Case No.: PWD-93-181

Street Address: 1447 HONEYSUCKLE DR NE

BERNALILLO COUNTY PUBLIC WORKS DEPARTMENT
CASE FILE COMMENTS

RE: ENGINEER'S CERTIFICATION FOR LOT 1447, UNIT 14, SANDIA HEIGHTS SOUTH
(D23/D35), SUBMITTED FOR CERTIFICATE OF OCCUPANCY APPROVAL,
ENGINEER'S STAMP DATED 10/24/94.

GRADING AND DRAINAGE PLAN
1447 HONEYSUCKLE DR. NE

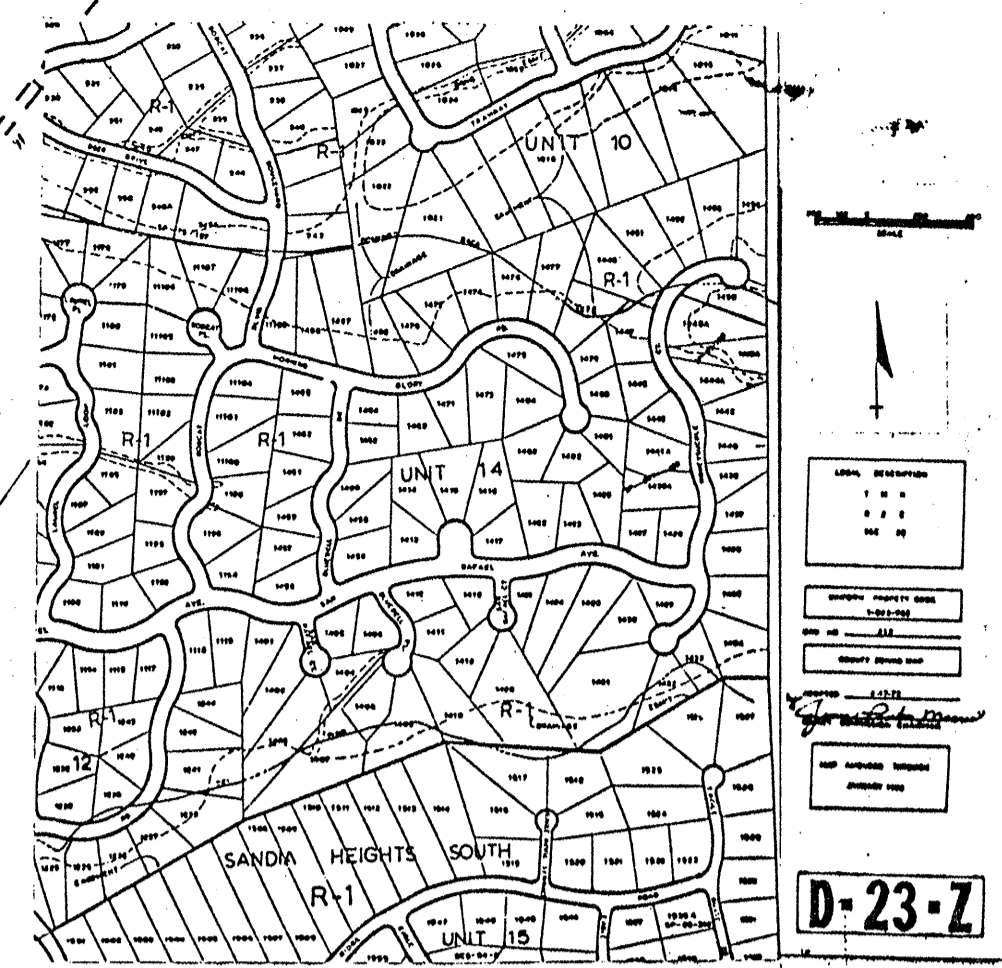
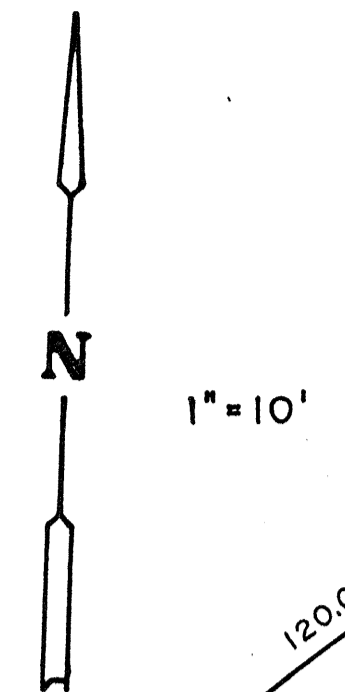
- 26-OCT-94 DRAN: The Floodplain Administrator has completed review of this case and comments are as follows:
1. Based on the information provided on the grading and drainage plan, with engineer's seal dated 10-24-94, this plan appears to meet the requirements established for this area and is therefore acceptable.

2. As shown on this plan offsite areas drain through this property and will continue to drain through this property after development. Also, as shown on this plan, no external or property line walls or fences, which includes chain link fencing, will be constructed which may impede offsite drainage areas from continuing to drain through this property.

3. Development of this property must conform to this plan. Any proposed changes will require a revision to the plan prior to initiating the proposed change.

The above referenced plan shows railroad ties and a rock cobble stabilized bank that were built within AMAFCA's drainage easement. The easement document specifically states that no fence, or wall, and no alteration of the grades or contours are allowed within the easement without written approval by AMAFCA. Please provide me with a copy of the encroachment agreement.

GRADING AND DRAINAGE PLAN
 1447 HONEYSUCKLE DR. NE

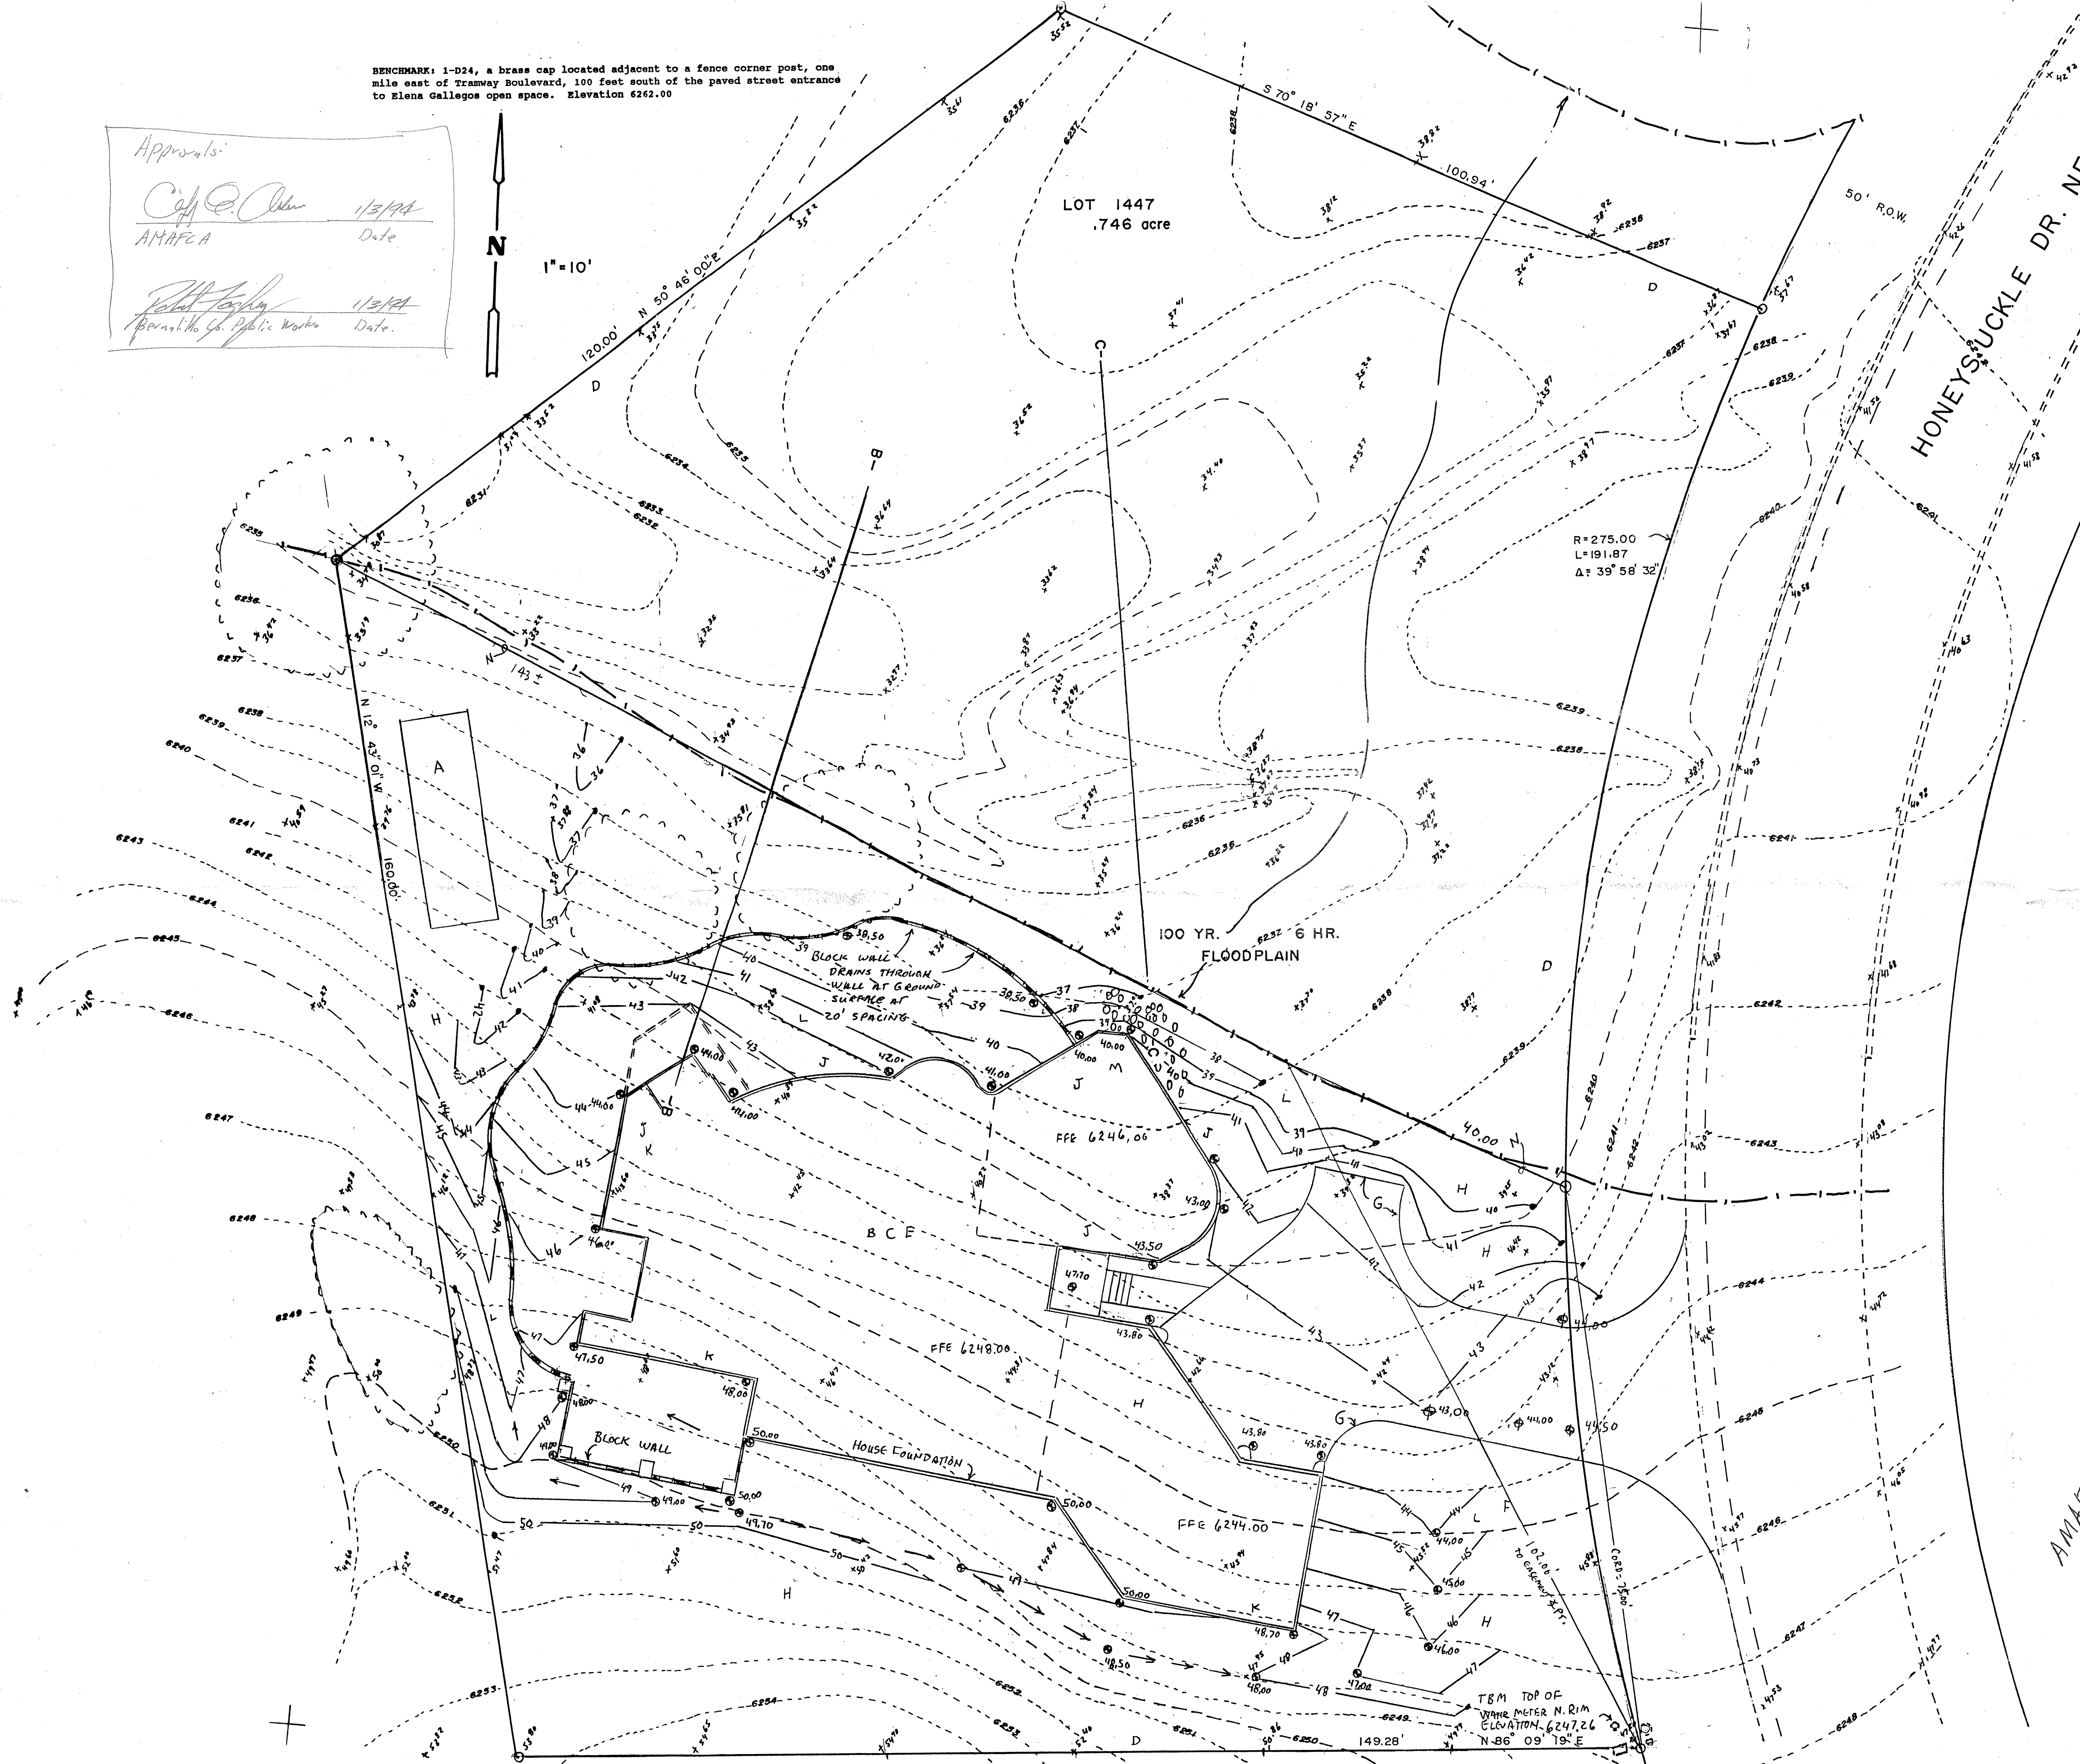
RE: DRAINAGE PLAN FOR LOT 1447, UNIT 14, SANDIA HEIGHTS SOUTH (D23/D35)
ENGINEER'S STAMP DATED NOVEMBER 19, 1993.

Please be advised that prior to release of the Building Permit, an easement dedicated and accepted by AMAFCA is required.
